TransGrid's Response to AER Request for Information- HumeLink

Date received:	26 August 2021
Date responded	1 September 2021
Topic	HumeLink (PEC) RIT-T
RFI	1.0

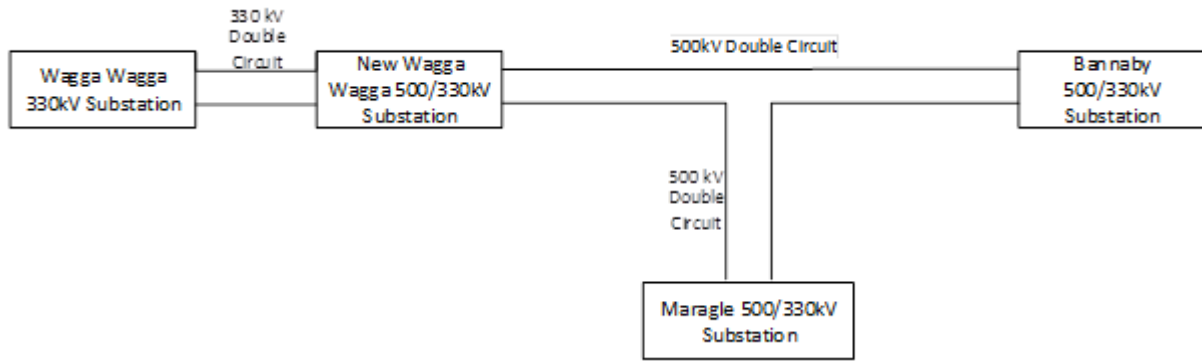
2. Please provide details on the indicative route assumed for the preferred option and other credible options in the PACR for the purposes of estimating costs, and provide a breakdown of the estimated biodiversity costs associated with the preferred option in the PACR. In particular, please advise whether these cost estimates cover the costs associated with different routes that may be determined in post RIT-T processes.

All circuit options considered in the PACR are based on circuit lengths defined by the required nodal points and provide comparable costs across all options. The estimated biodiversity costs for the preferred option, 3C is \$953m. The capital costs used in the PACR are 'P50' estimates, i.e. there is equal probability of the cost being above or below these estimates.

As noted above, the preferred route will be identified by the activities undertaken as part of our initial Contingent Project Application (CPA) including the planning approvals process (specifically EIS).

As the Project progresses and the route is defined, the forecast delivery cost will be updated. Should the forecast cost increase above the cost estimate in the PACR, then we will seek AEMO's feedback loop confirmation that the Project remains on the optimal development path at that cost prior to submitting our final CPA. Our final CPA will include the final forecast delivery cost based on the specified route.
